PG&E Letter HIL-05-007

Humboldt Bay Independent Spent Fuel Storage Installation
Response to NRC Request for Additional Information for the Humboldt Bay
Independent Spent Fuel Storage Installation Application (TAC NO. L23683)

**PG&E Response to Request for Additional Information
Humboldt Bay Independent Spent Fuel Storage Installation (ISFSI)
License Application**

FIGURE 1:
NET ACCELERATION AT BASE OF HI-STAR HB USING DBE2

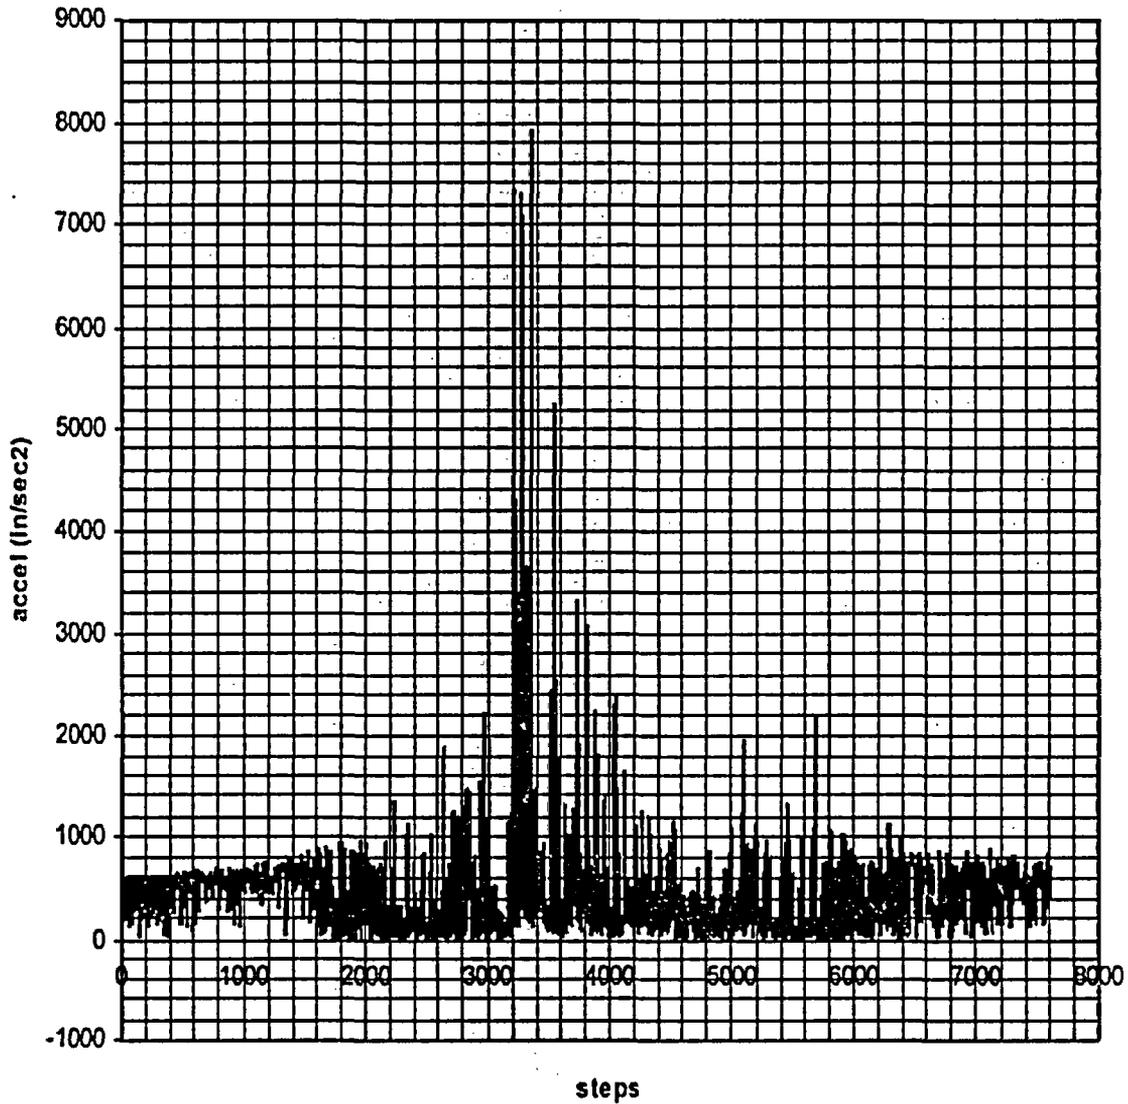
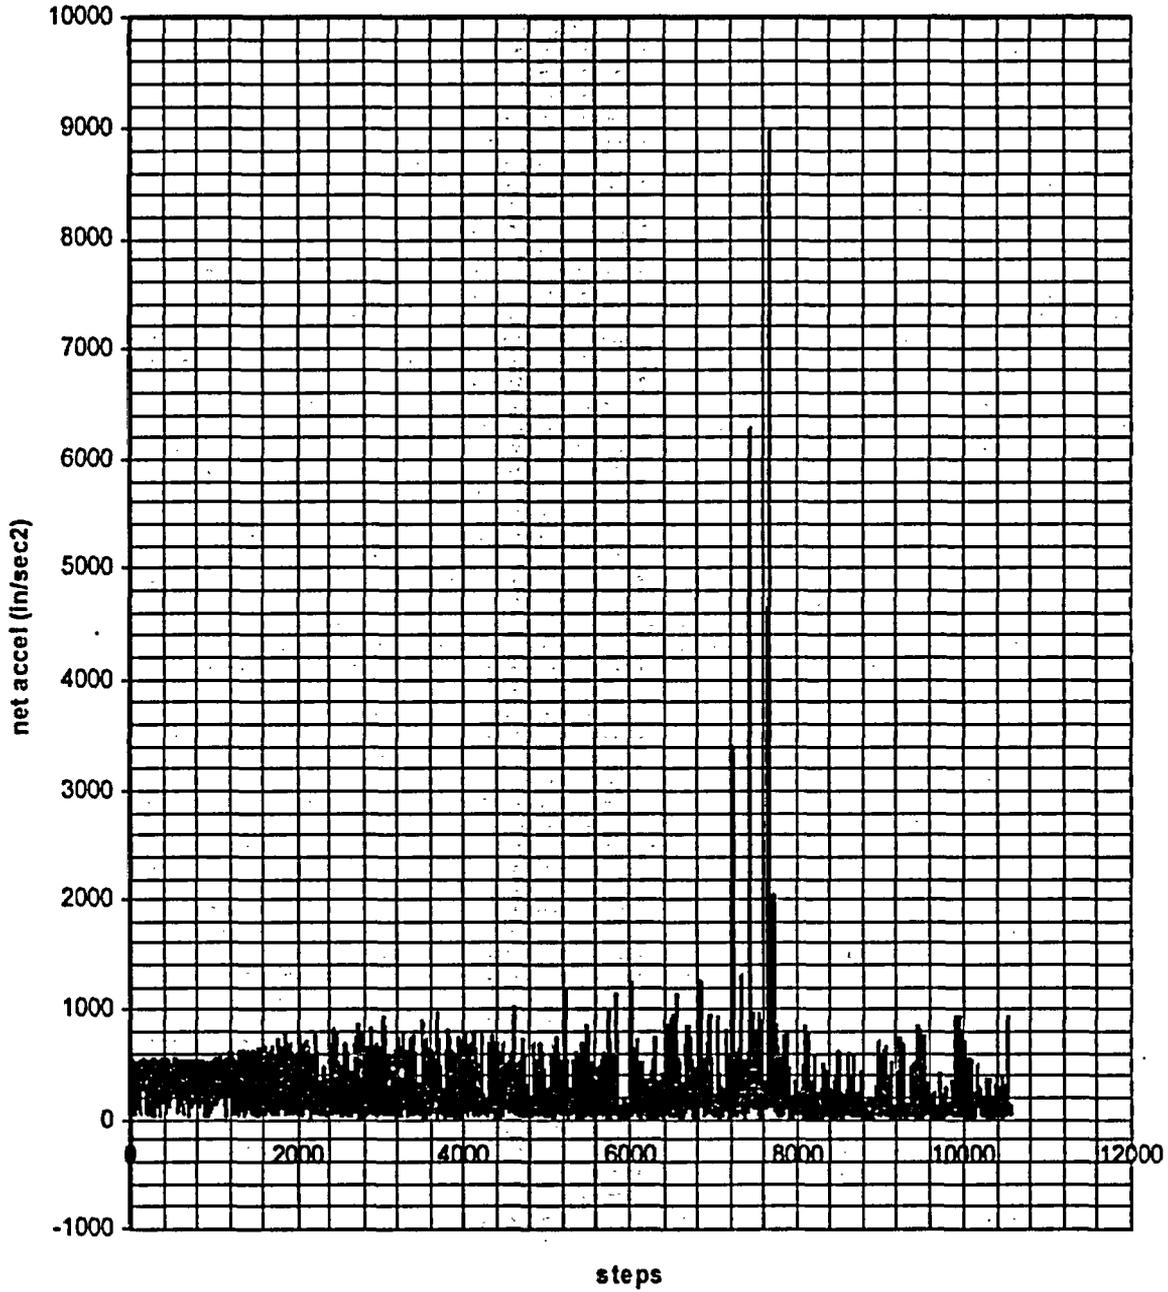
The staff considers that if only one DBE is used for the reevaluation, it should correspond to the ground motion that produces the maximum resultant impact load, instead of the maximum vertical impact load. Studies of dynamic impact on fuel assemblies indicate that bending (caused by lateral impact) and not axial failure controls the performance of these components (Chun et al, 1987). The staff has reviewed the resulting decelerations under the original ground motion events (Figures 5 thru 12 in Holtec report HI-2033014). The justification presented by the applicant for selecting DBE-3 is not consistent with the information of HI-2033014. For instance, Figures 7 and 9 of this report indicate that the maximum acceleration of the top restraint in the vertical ("Az") direction is larger for DBE-2 ($1690 \text{ in/sec}^2 = 4.4 \text{ g's}$) than for DBE-3 ($926.5 \text{ in/sec}^2 = 2.4 \text{ g's}$). Also, the maximum resultant acceleration at the top restraint is larger for DBE-2 than for DBE-3. The staff acknowledges that some of these accelerations may correspond to the spurious large decelerations at the beginning of time history. However, Figures 5 thru 12 of HI-2033014, indicate that the maximum decelerations (or contact forces) do not take place at the beginning of the time history, but always close to the peak ground acceleration. Therefore, the staff needs a clarification for using DBE-3, rather than DBE-2 as the basis for the analyses of Appendix E of HI-2033014.

computed and plotted over the strong motion duration of both events. Figures 1 and 2 to this response present the results obtained at the base of the cask for the DBE2 and DBE3 event, respectively. Figures 3 and 4 to this response present the results at the top of the cask. The largest magnitude of the net acceleration is found at the base of the cask for the DBE3 event. The net accelerations at the top of the cask for both events were significantly lower, although the DBE2 event gave a peak value that did exceed the peak for the DBE3 event.

From the results of the evaluation, if the largest magnitude of the net acceleration is used as the criterion to define the "bounding" event for the study investigating the effect of vertical amplification, then the DBE3 seismic event is the proper event to provide the input for the study. Using as a criterion either the maximum net acceleration of the cask, or the maximum impact load at the base, results in the DBE3 seismic event as being the "most limiting event". Thus, the submitted results using the DBE3 event are appropriate for the dynamic simulations performed to respond to the RAI question of the effect of amplification of the vertical seismic event.
